From: [Griffiths, Bryn](#)
To: [Wylfa Newydd](#)
Cc: [Wylfa Newydd DCO; Energy Island](#)
Subject: Natural Resources Wales: Deadline 2 submission - Wylfa Newydd Nuclear Power Station (Our ref: 20011606)
Date: 04 December 2018 11:45:39
Attachments: [2018.12.04 NRW - Written Representation - 20011606.pdf](#)

**GORSAF BŴER NIWCLEAR ARFAETHEDIG WYLFA NEWYDD / PROPOSED
WYLFA NEWYDD NUCLEAR POWER STATION**

**CYFEIRNOD YR AROLYGIAETH GYNLLUNIO / PLANNING INSPECTORATE
REFERENCE: EN10007**

RE: NATURAL RESOURCES WALES' WRITTEN SUBMISSION FOR DEADLINE 2

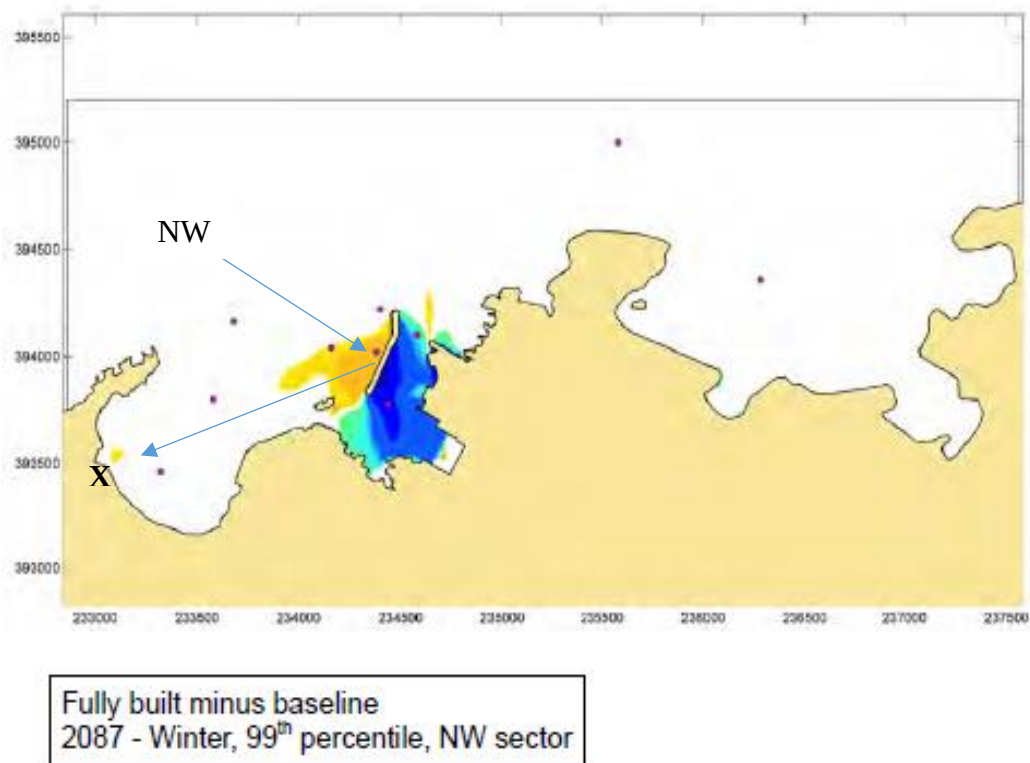
- 7.10.12. The wave modelling shows that when waves approach the western breakwater from the north west, during extreme storm events, they reflect off the structure and are redirected so that the energy is focussed on a small area of Esgair Gemlyn towards the western end of the ridge. Insufficient evidence has been presented to demonstrate whether the reflected wave will change the sediment movement in that area over the lifetime of the project. There are gaps in the modelling assessment undertaken by the Applicant which relates the waves to the sediment dynamics during storm conditions from the north west. Changes in wave energy leading to changes in sediment movement could change the shape and height of the ridge at the western end and potentially result in more wave overtopping, or even a breach in the ridge which would affect the integrity and functioning of Cemlyn Lagoon.

- 7.10.13. Waves from the north west are generally smaller than waves from the north east, however it may not be a linear association and the biggest impact on the ridge may be from more frequent and/or smaller but more focused waves which are reflected off the western breakwater (see Figure 10 below). NRW advise that this smaller but more frequent focussing of energy by the western breakwater needs to be further understood to ensure that there is no detriment to the shingle ridge through erosion or breaching events over the lifetime of the project.

- 7.10.14. It is largely unknown how the ridge has responded to past wave events. There is therefore, a gap in the baseline understanding of the response of Esgair Gemlyn to storm events from different directions.
